# The Town of Hilton Head Island Regular Design Review Board Meeting

Tuesday, June 8, 2010

## AGENDA

COTTON HOPE I & II PAINTING PROJECT

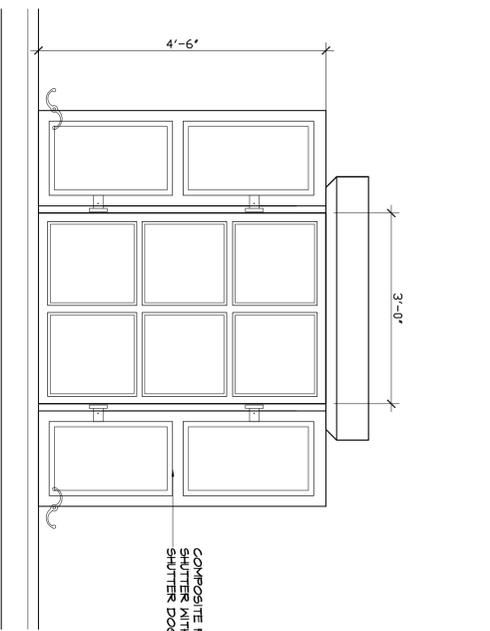
<b>ARCHITECTURAL DESIGN</b>		
Staff would like to see all railing elements painted, whether they are visible from the street/ parking lot or not.		
DESIGN GUIDE/LMO CRITERIA	COMPLIES YES/NO/N/A	COMMENTS OR CONDITIONS
Structure is designed to be appropriate to the neighborhood		
Promotes pedestrian scale and circulation		
Design is unobtrusive and set into the natural environment		
Utilizes natural materials and colors		
Avoids distinctive vernacular styles		
Design is appropriate for its use		
All facades are have equal design characteristics		
Avoids monotonous planes or unrelieved repetition		
Has a strong roof form with enough variety to provide visual interest		
Minimum roof pitch of 6/12		
Overhangs are sufficient for the façade height.		
Forms an details are sufficient to reduce the mass of the structure		
Human scale is achieved by the use of proper proportions and architectural elements		
Utilizes a variety of materials, textures and colors

Accessory elements are design to coordinate with the primary structure		
<b>LANDSCAPE DESIGN</b>		
Any material to be removed or damaged during painting should be replaced in kind upon completion		
<b>DESIGN GUIDE/LMO CRITERIA</b>	<b>COMPLIES YES/NO/NA</b>	<b>COMMENTS OR CONDITIONS</b>
Treats the Landscape as a major element of the project		
Provides Landscaping of a scope and size that is in proportion to the scale of the development		
Landscape is designed so that it may be maintained in its natural shape and size		
Preserves a variety of existing native trees and shrubs		
Provides for a harmonious setting for the site's structures, parking areas or other construction		
Location of existing trees and new trees provides street buffers, mitigation for parking lots, and an architectural complement that visually mitigates between parking lots and building(s)		
Shrubs are selected to complement the natural setting, provide visual interest and screen less desirable elements of the project

**FAUX WINDOW DETAIL**  
SCALE = 3/4" = 1'-0"

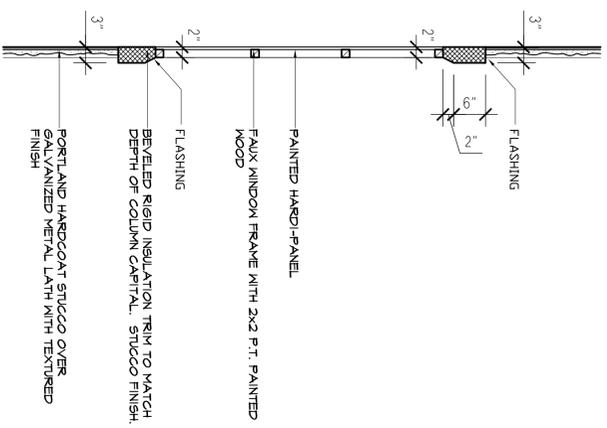
Human scale is achieved by the use of proper proportions and architectural elements	Y	Suggests removing functioning windows with faux windows at the street elevation, although the floor plan doesn't indicate why. Some detail at the first floor on the street elevation might break up the façade and give the building a more human scale at the ground level
Utilizes a variety of materials, textures and colors	Y	
Incorporates wood or wood simulating materials	Y/N	Where practical
Windows are in proportion to the facade	Y/N	See window comment above
Details are clean, simple and appropriate while avoiding excessive ornamentation	Y	Would like to see more details on the trellis for clarification
Utilities and equipment are concealed from view	Y	
Decorative lighting is limited and low wattage and adds to the visual character	Y	
Accessory elements are design to coordinate with the primary structure	Y	Green railing and fence might complement the building more in a colors selected for building and trim, rather than the roof. Most green fences that have been approved were to blend into a natural setting, whereas most service yards are reviewed to blend with the structure

**SITE PLAN**  
 CONCEPTUAL 05.05.10  
 SCALE 1/16" = 1'-0"

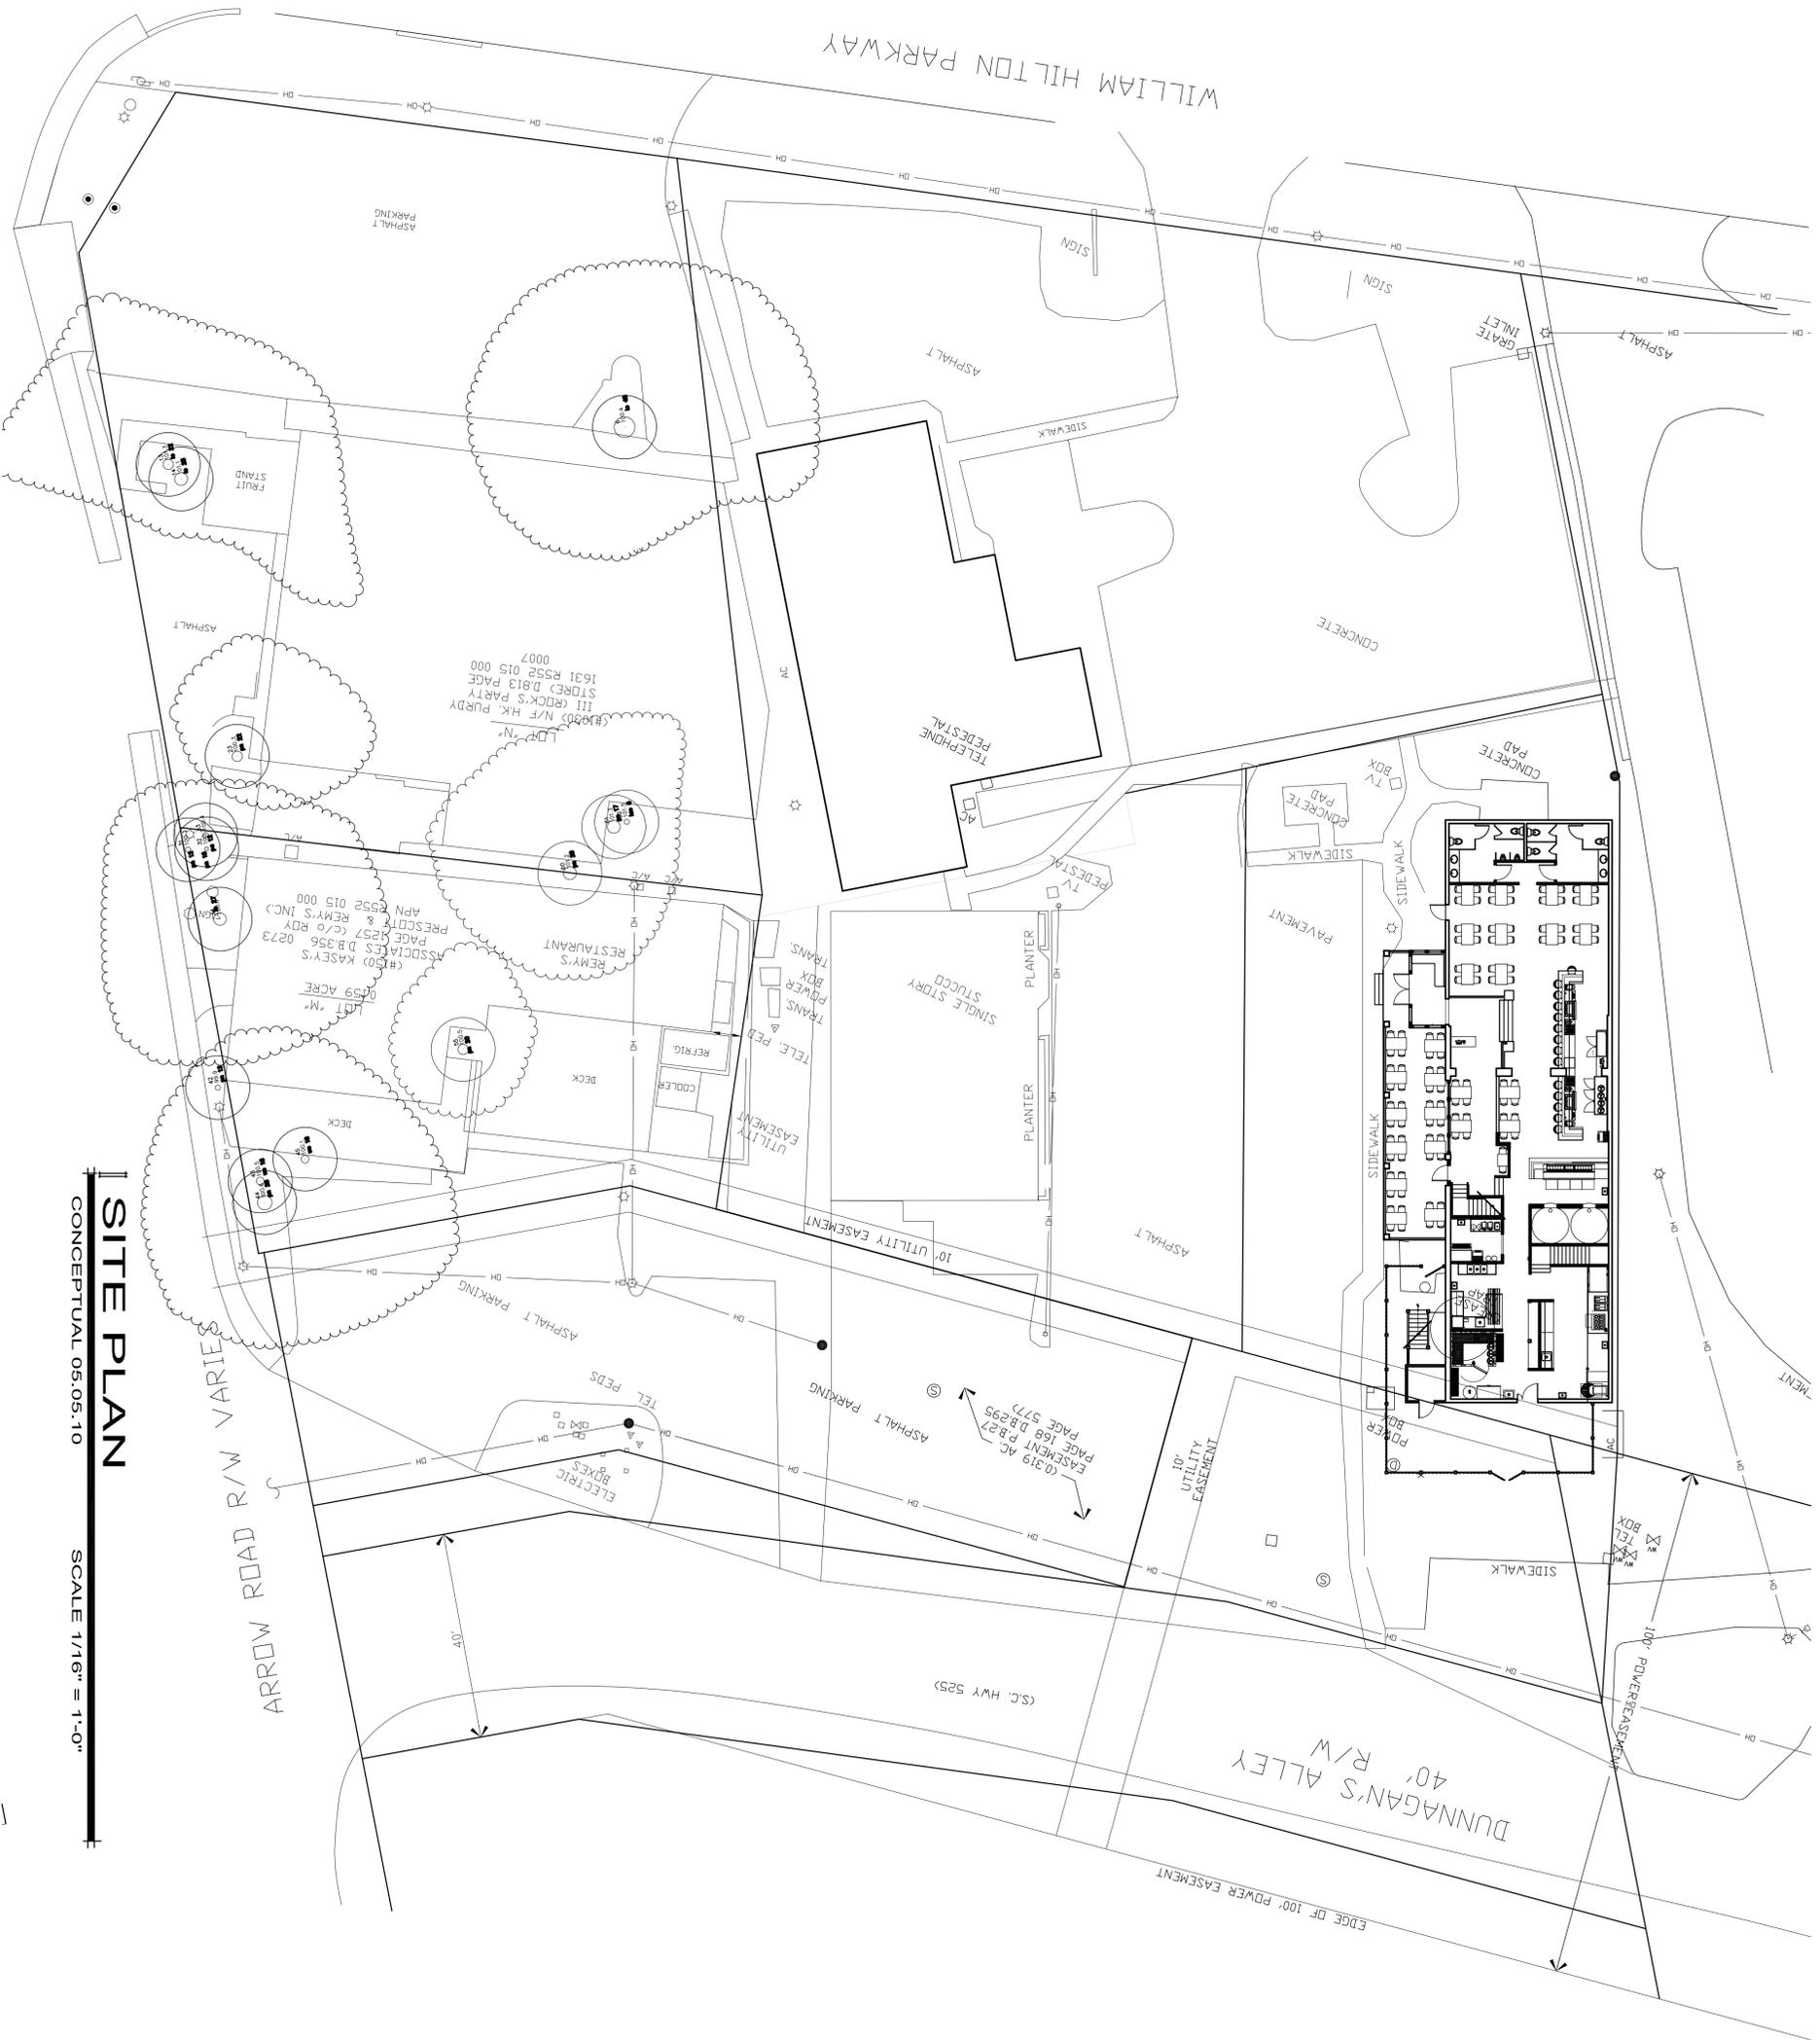
There is no landscape plan submitted, although a significant opportunity to improve the landscaping on the site. Staff would like to see a plan, although would recommend approval of the building separately, with a landscape plan to be submitted and reviewed by the board at a later date.

DESIGN GUIDE/LMO CRITERIA	COMPLIES YES/NO/NA	COMMENTS OR CONDITIONS
An effort has been made to preserve existing trees and under story plants		The specimen live oak near the building needs to be shown on all site plans; we also need to have details that show what, if anything, will occur below ground under the tree’s canopy. Will any pruning be done to this tree in order to complete this project? If so, prior approval is required from NR.
Supplemental and replacement trees meet LMO requirements for size, species and number
